PRODUCT/PROCESS CHANGE NOTICE (PCN)

PCN #: **TB0902-01** DATE: **5-Mar-2009**
 Product Affected: IDT selective Plastic packages - PDIP,
 PLCC, PQFP, QVSOP, SSOP, SOIC,
 SOJ, TQFP, TSSOP, TSOP,
 Date Effective: **5-Jun-2009**

PLCC (PL/PLG, DL/DLG)

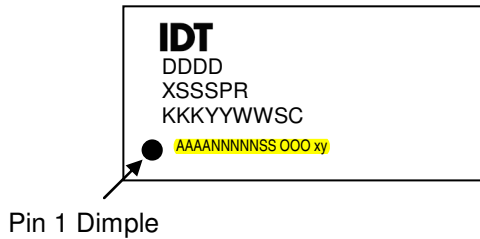
This notification is to advise our customers that IDT will convert lot traceability mark from the bottom of the package to the top of the package to facilitate lot traceability after board mount. This change is for a select group of products that were not previously converted to top mark traceability.

Attachment 1: Illustrates the location of the lot traceability mark on top of the package for all the affected package families.
